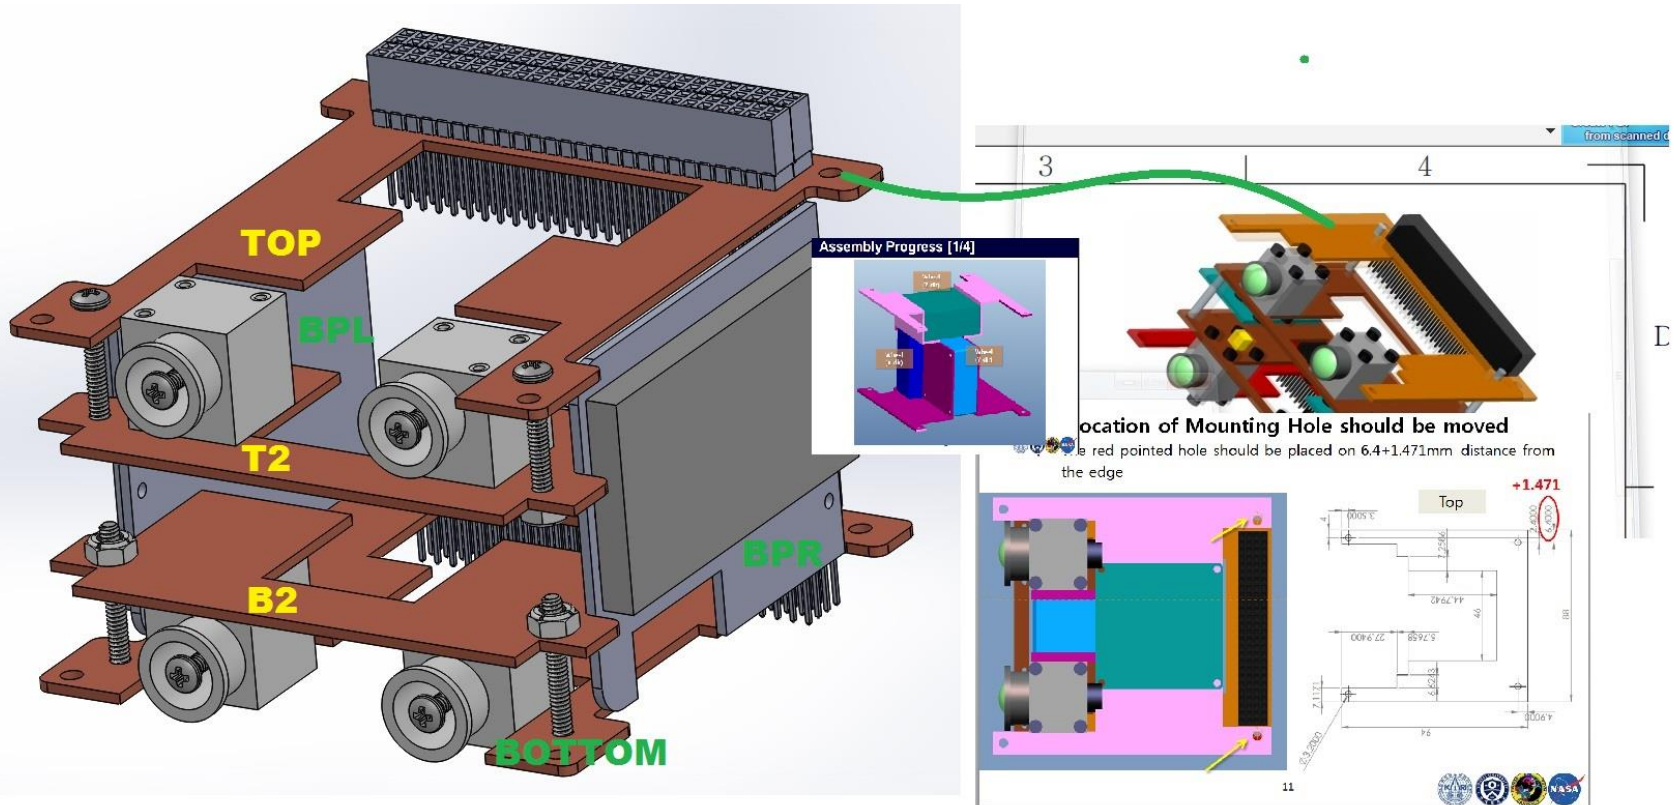
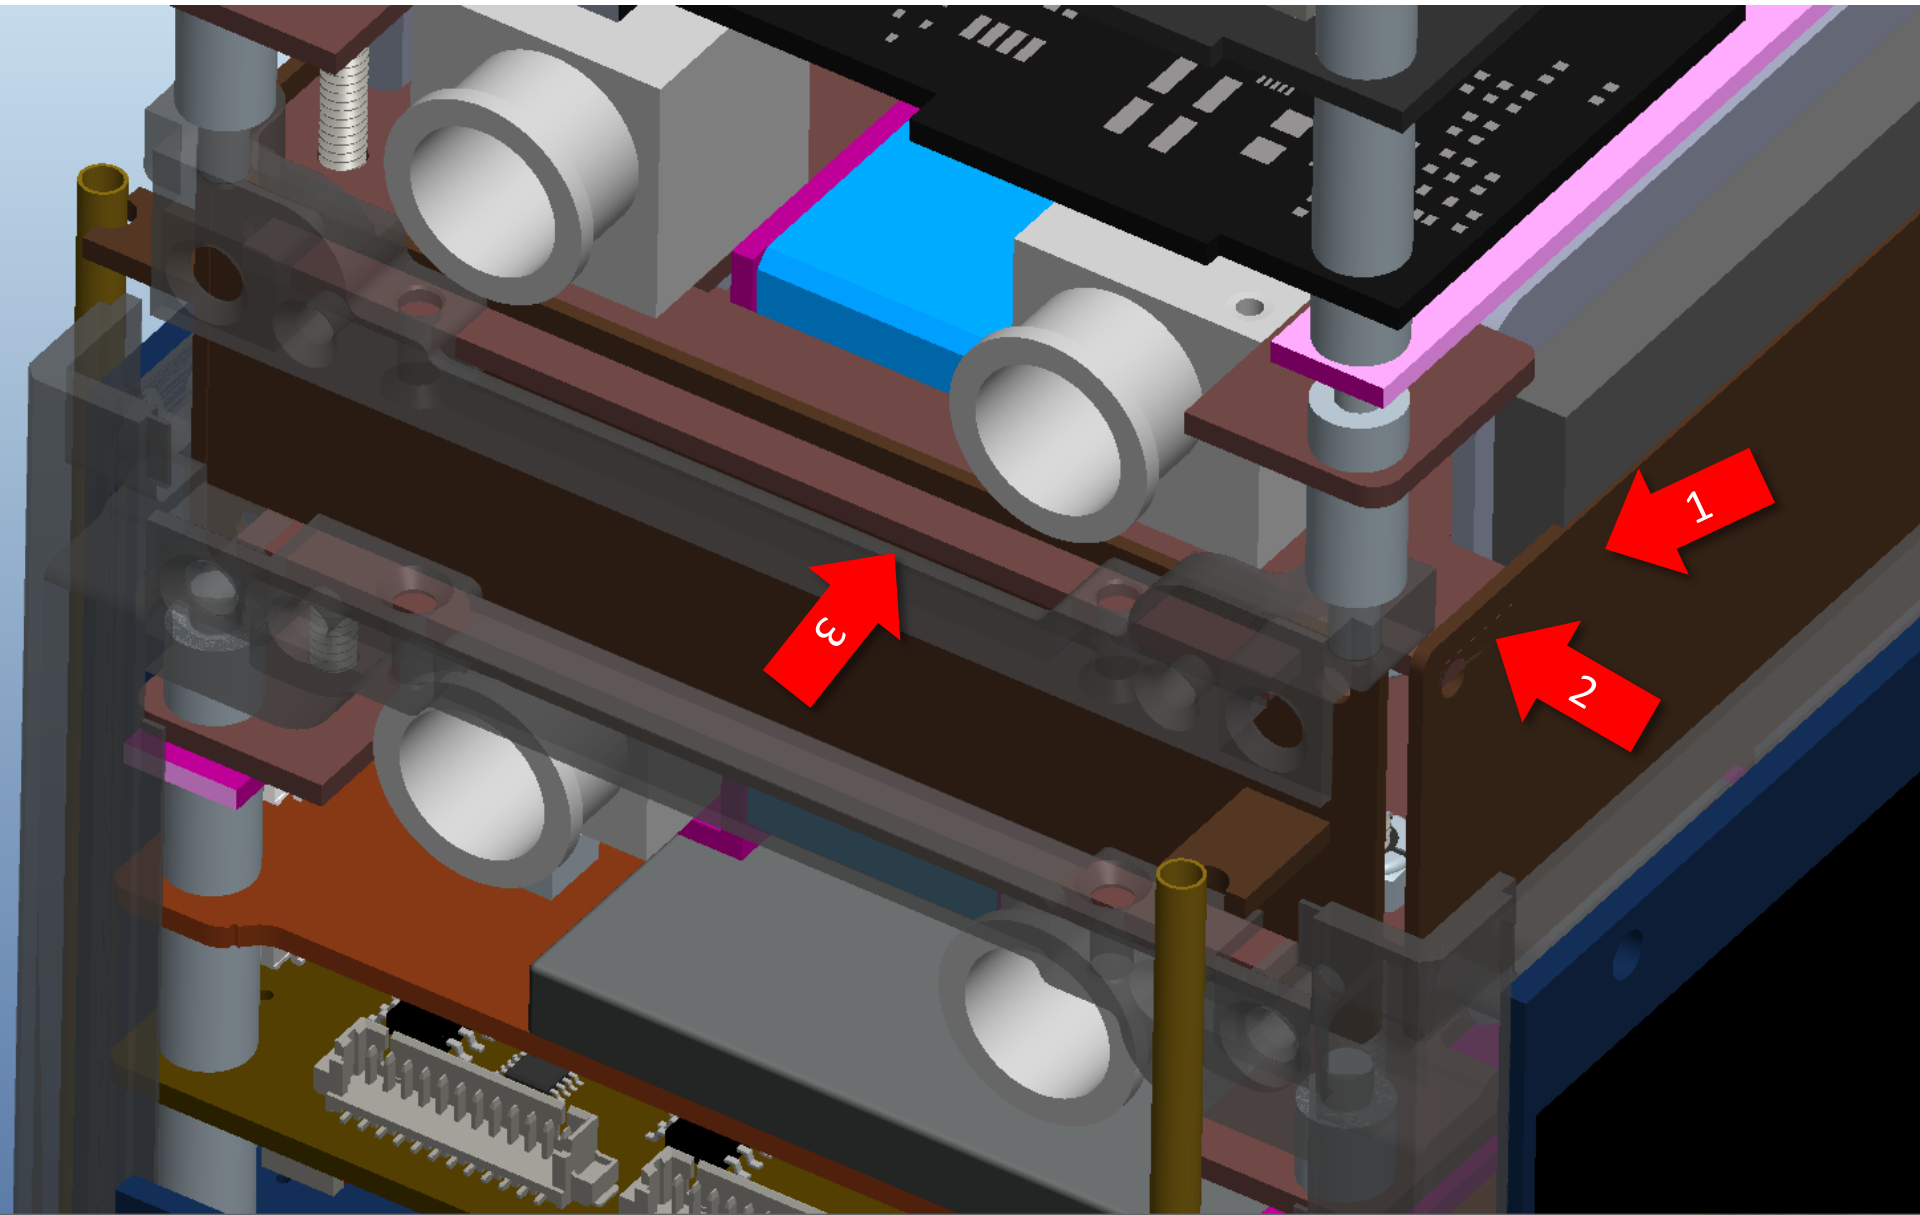
We checked your email. As you told on email, the inner cut area should be more larger to contain z-dir wheel. We hope the top board would be adjusted to be suited well in the Wheel Mount.

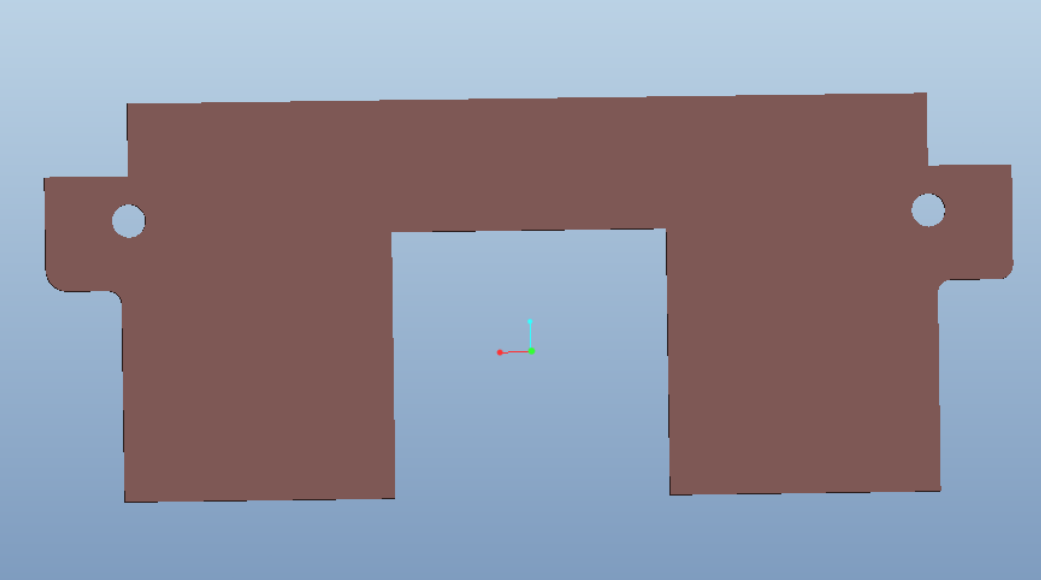
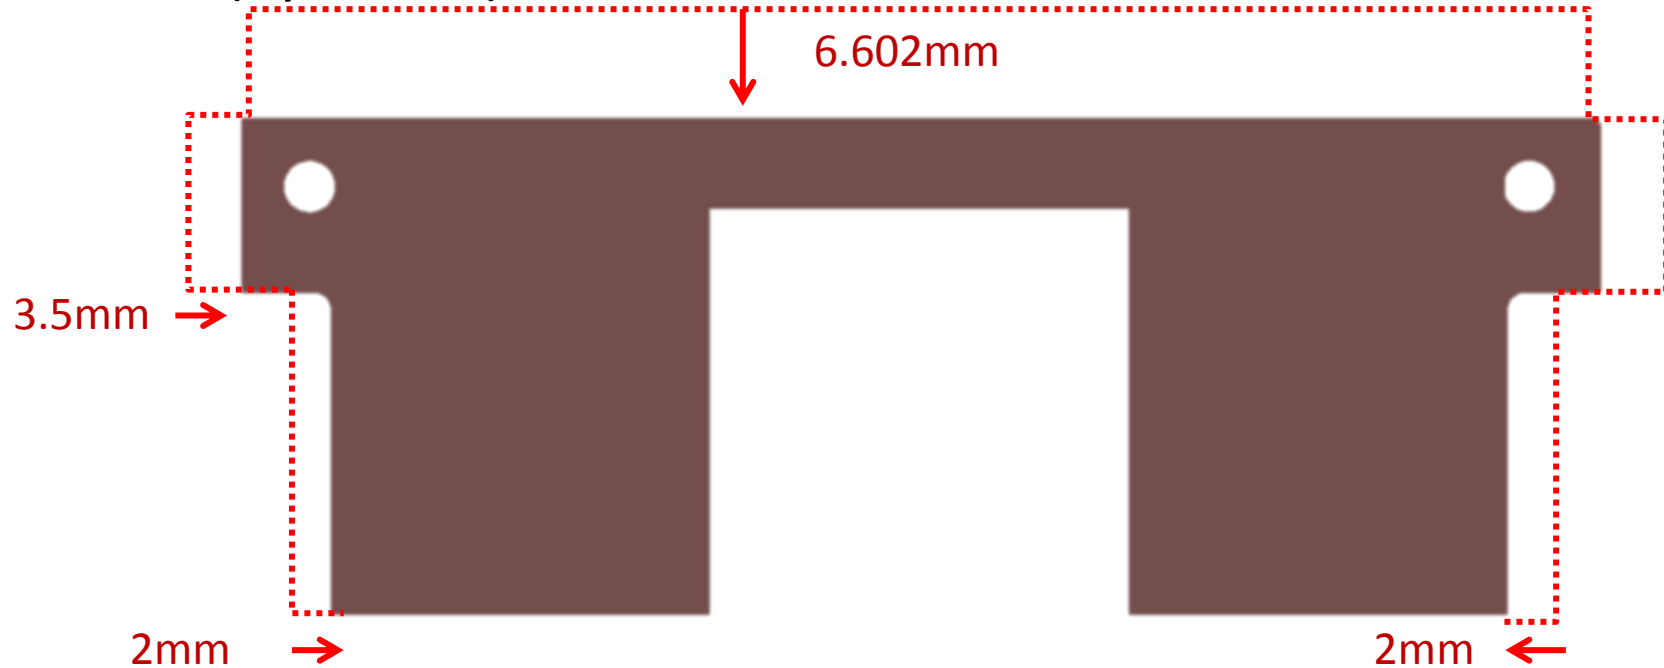
The T2 and B2 Board on the middle part should be revised

1. the BPL Boards interferes with the Gomspace's side interstage board.
- 2,3. the edge interferes with the Gomspace's side interstage board.

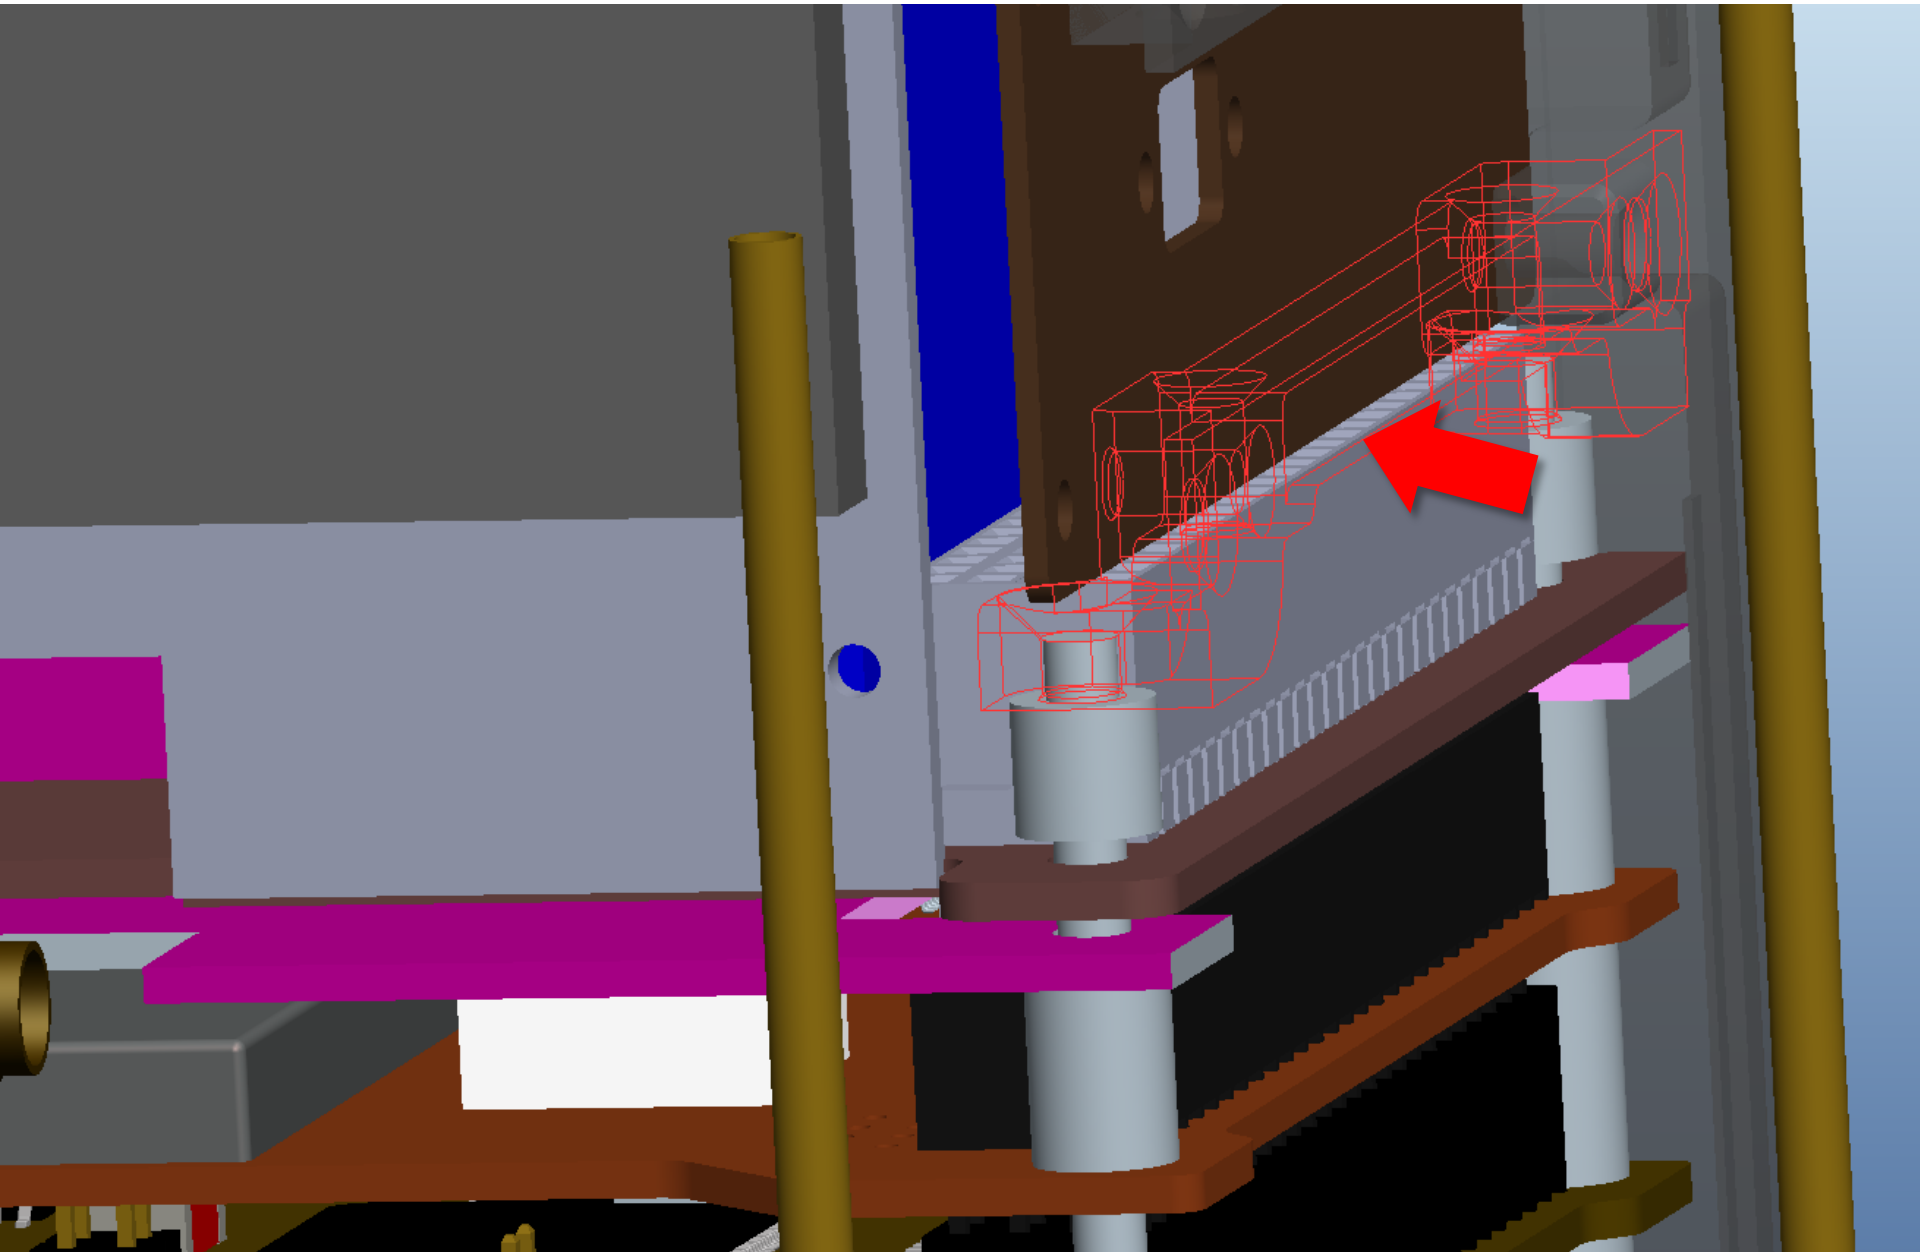
Is it possible to make the height of PC/104 connector on the bottom board more reduced?
Because there is interference between the rib of structure and the PC/104. I hope you could replace it by minimum height connector

1. Is it possible to make the length of thruster more longer about 4.3 mm, maintaining the location of the cube mount of thruster on board. It is not necessary but we are considering for the gap between the end of the thruster and the shear side panel of 2U CubeSat structure (4.262mm). I think it would be better if we can fill the gap in terms of preventing the repulsive force resulting from hitting the inner surface of the shear panel by the nozzle's jet ejection. (Or is it okay without extrusion of the nozzles from the outer surface of the shear side panel?)
2. Does bolts could be replaced by oval countersunk head screw and add the countersink hole on the boards? Because there are interrupts between the wheel mounts and the bolts' heads. But, if you don't recommend it for special reasons, we can make holes on the wheel mount.
3. The cut out space could be lessened about 5~7mm heights.

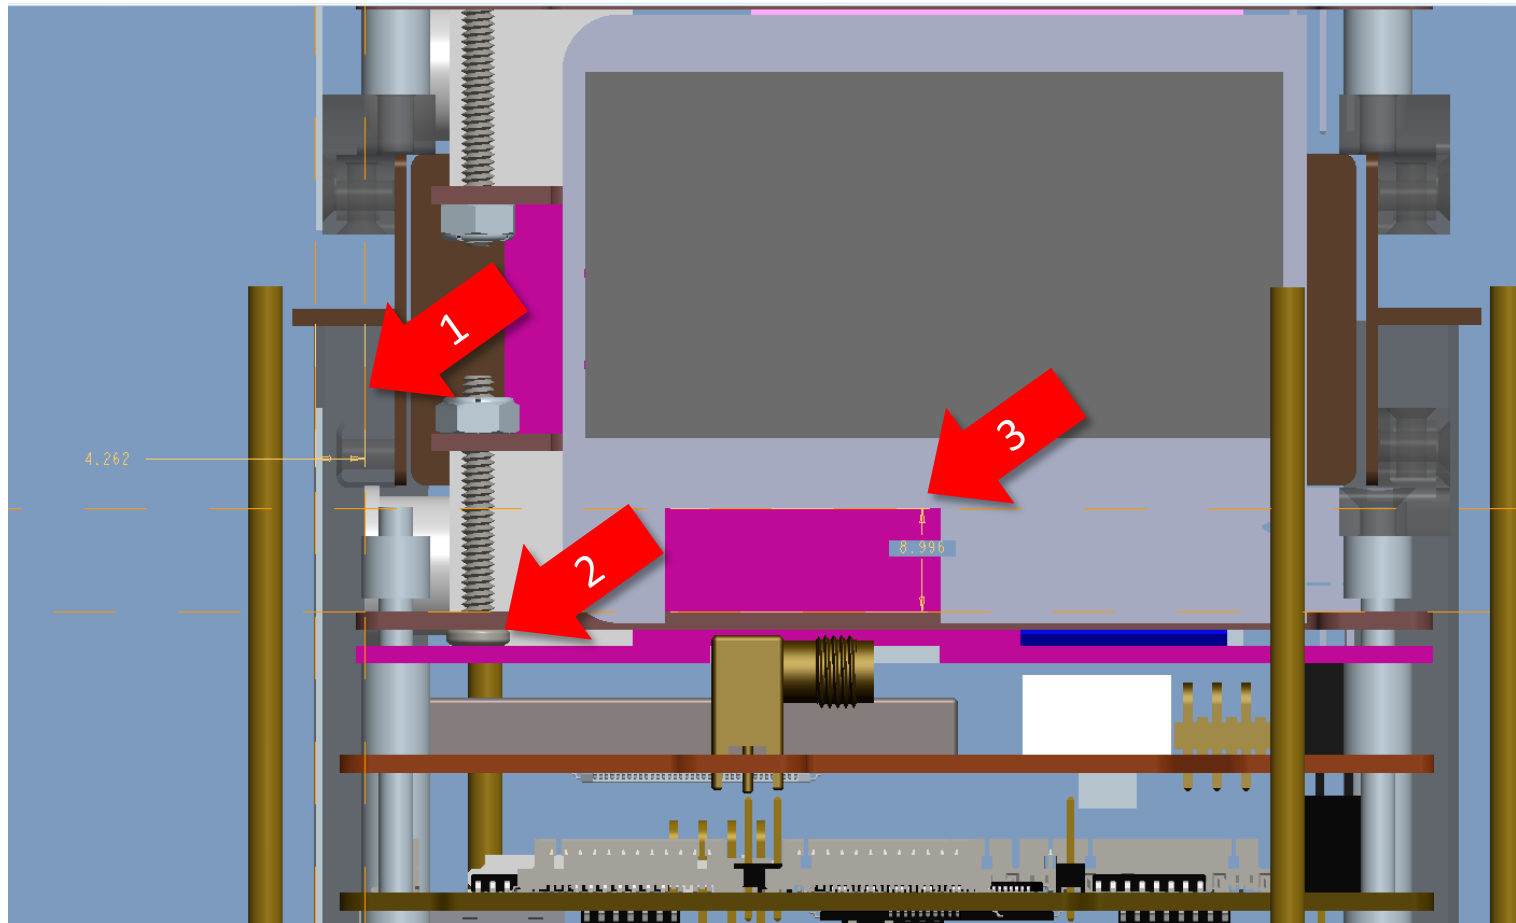
3. You can have more space on there as I mentioned previous slide.

4. Is gray part on BPR board as well?
